PRODUCT BULLETIN

Bulletin No: PB419
Issue Date: 6-14-2018
Effective Date: 6-14-2018

Description/Title:
New Spacer for Feeder Tube Unit and FX-1001

Part No:
B5183

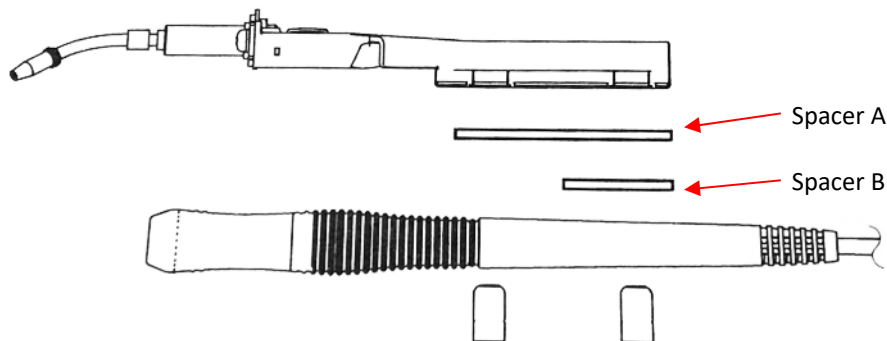
When using the HAKKO 373 or HAKKO 374 Solder Feeder units, these spacers are required when attaching the tube unit (PNs: B3477 or B3478) to the FX-1001 Handpiece. The spacers are a foam rubber with adhesive on one side. The larger spacer (Spacer A) should be attached to the bottom of the tube unit using the adhesive side. The smaller spacer (Spacer B) should be attached to Spacer A, again using the adhesive side. After the spacers have been attached, the tube unit can be attached to the handpiece using the metal clips that were included with the tube unit. See the diagram below.

Material	Foam Rubber
Color	Black
Size	Spacer A – 50 x 10 mm Spacer B – 25 x 10 mm
Attachment	Adhesive – Single Side
